Burlington Development Review Board

Tuesday, April 2, 2024, 5:00 PM

To: Development Review Board
From: Mary O'Neil, AICP, Principal Planner
Date: April 2, 2024
RE: ZP-24-23; 23 Catherine Street

Request: Demo and remove existing one story, 12'x19', single bay garage and construct a 12' x 19' habitable space as an expansion of the existing single family home. Installation of a stone patio.

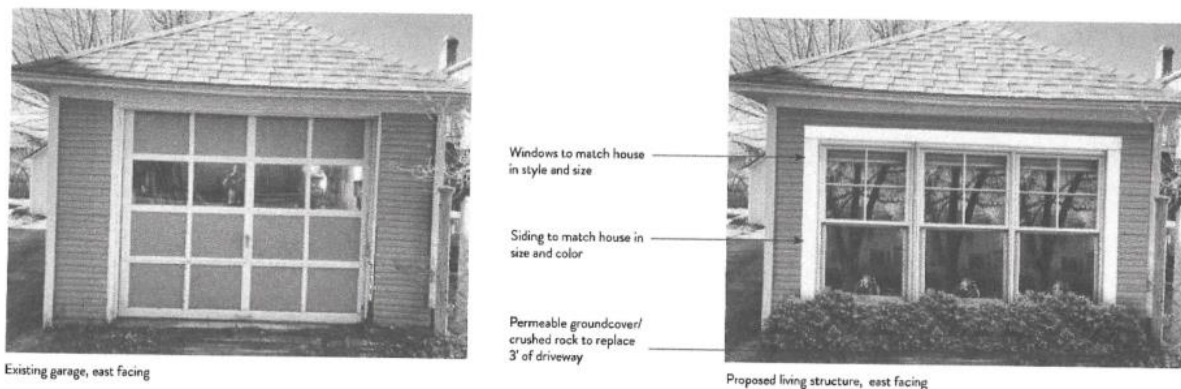
Design features which address the effects of rain, snow, and ice at building entrances, and to provisions for snow and ice removal or storage from circulation areas shall also be incorporated.

Other than a minor eave line, there is no canopy over the entrance to the new unit. Some form of relief from inclement weather at the building entrance is recommended.

As the site is already so tightly constrained, snow storage will likely replicate conditions already in place. **Affirmative finding as conditioned.**
